TECHNICAL BULLETIN

DATE: 18 MAY 1971

MODIFICATION KIT (M50436) – ENGINE–OUT WARNING HORN SUPPORT

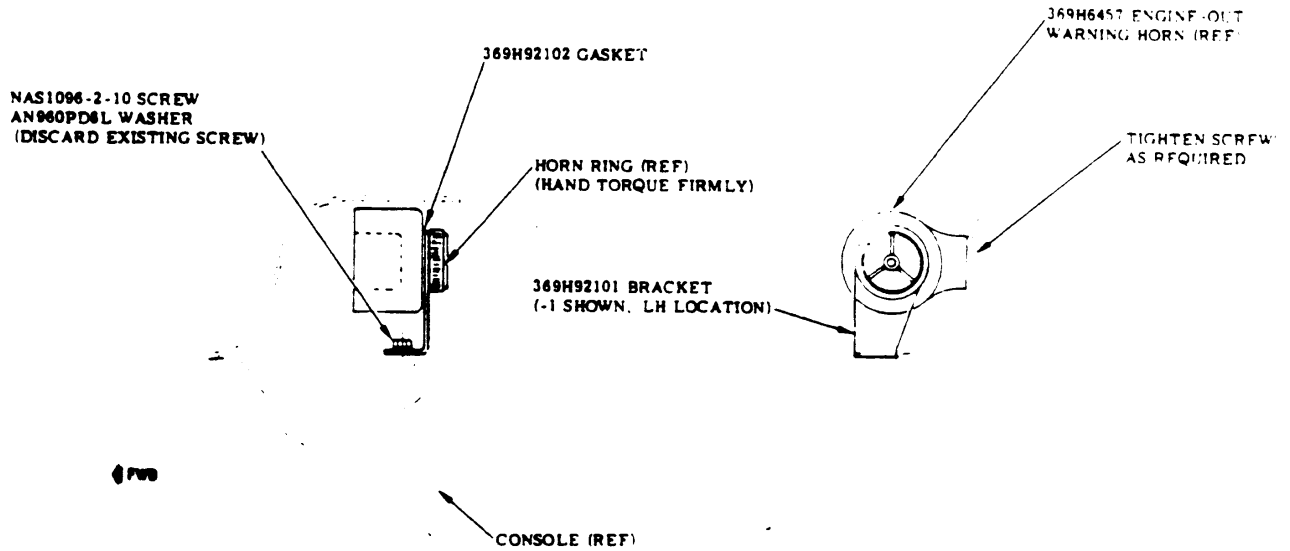
- a. Check that all electrical power is OFF.
- b. Back off and remove ring on horn assembly. (See Figure I)
- c. Install gasket and -1 or -2 support bracket as applicable; secure loosely with horn ring.
- d. Install bracket to instrument console side fairing with new screw and washer; discard existing screw.
- e. Hand torque ring on horn to secure bracket firmly.
- f. As required, tighten screws securing horn to center fairing (remove center fairing with warning unit, per Section 17 of Basic HMI, to gain access to attachment screws).
- g. Check new support bracket installation for discrepancies.
- h. Perform operational check of engine-out audible warning unit.

FIGURE 1. MODIFICATION KIT - ENGINE-OUT WARNING HORN SUPPORT (M50436)

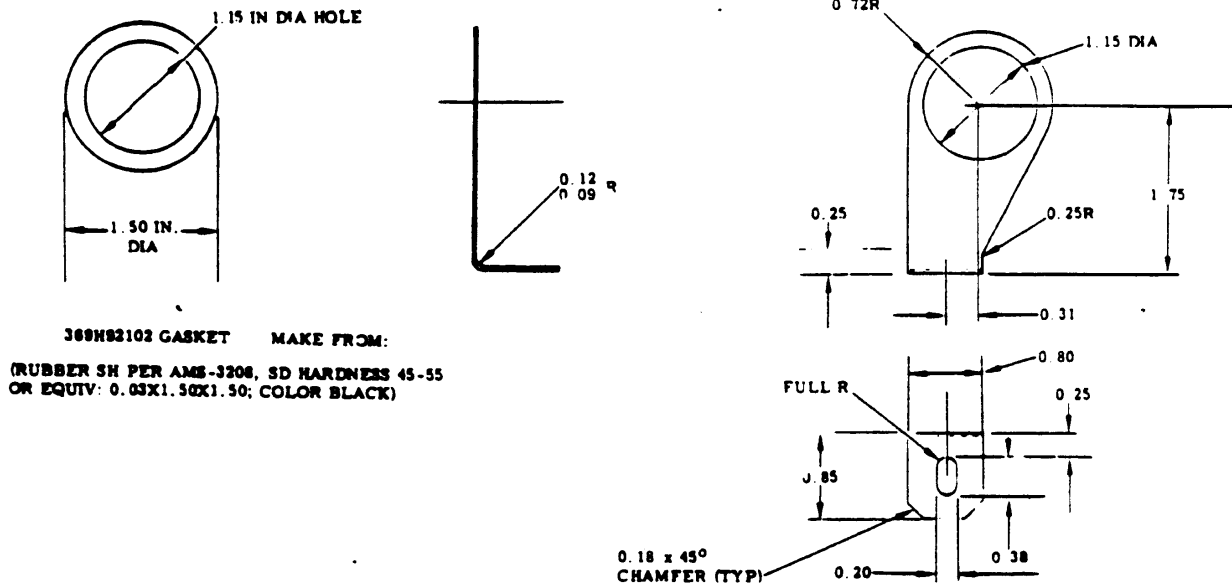
The information given in this Service Information Notice lists a procedure for installation of a support bracket to minimize vibration of the engine–out audible warning unit.

The M50436–1 kit configuration is applicable to affected 369HE and 369HS helicopters with the warning horn located on the left–hand instrument console fairing (standard position). The –2 configuration is applicable to 369HS helicopters with the warning horn on the right–hand instrument console fairing (optional position).

369H92101 SUPPORT BRACKET
(-1 SHOWN, LH LOCATION; -2 OPPOSITE, RH LOCATION)

MAKE FROM: (AL ALY SH 2024-T3; QQ-A-250 5,
TEMP T3; FINISH PAINT BLK NO. 37038 FED STD 595)

369H92102 GASKET MAKE FROM:
(RUBBER SH PER AMS-3206, SD HARDNESS 45-55
OR EQUIV: 0.03X1.50X1.50; COLOR BLACK)
